Project: **MUSEUMS DISCOVERY CENTRE
CASTLE HILL

PROPOSED BUILDING J**

Report: **BCA ASSESSMENT REPORT**

Reference: **2019-0001-r3**

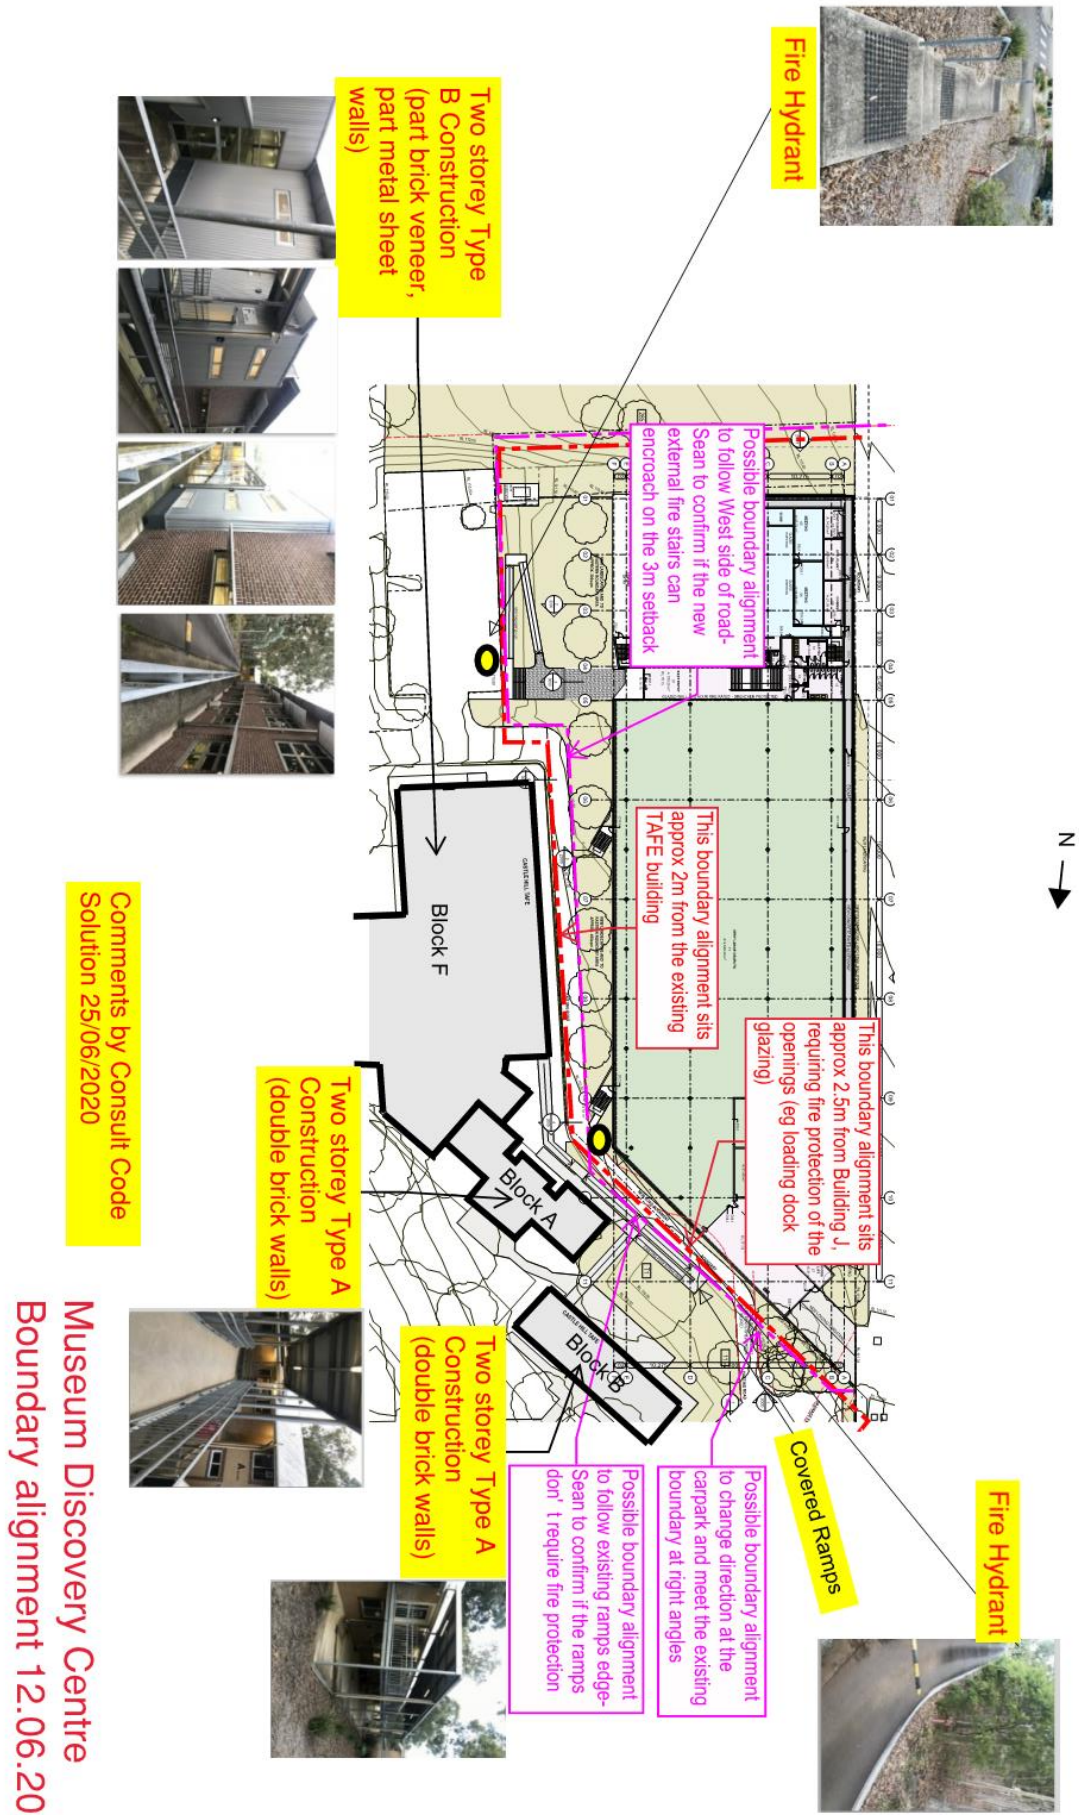
However, the proposed new eastern boundary re-alignment towards the TAFE site will result in the existing western walls and parts of the northern and southern walls of Block F being within

18m of a FSF ie the proposed new allotment boundary, if assessed under the Deemed-to-Satisfy provisions of the BCA such external walls would be required to be fire rated.

BCA Specification C1.1 requires that the loadbearing parts of external walls that are within 18m of a FSF must have an FRL of 120minutes. Non-load bearing parts of the external walls that are more than 3m from a FSF do not require an FRL.

Therefore, the proposal to create a new allotment boundary which is less than 18m from the external walls of the existing TAFE Block F will result in a non-compliance with the Deemed-to-Satisfy provisions of Clause C1.1 of the BCA.

Also during our inspection, it was noticed that two existing fire hydrants that would serve the existing TAFE buildings are located either within the area or in close proximity to the area proposed for the new allotment. - see the attached plan mark-up.

The need to relocate one or more of these fire hydrants will need to be investigated.

However, provided the external walls of the new Building J is located at least 6m away from the external walls of any of the existing TAFE buildings it is considered that a Performance Based Fire Engineered Alternative Solution could be developed to justify compliance with the Performance Requirements of the BCA.
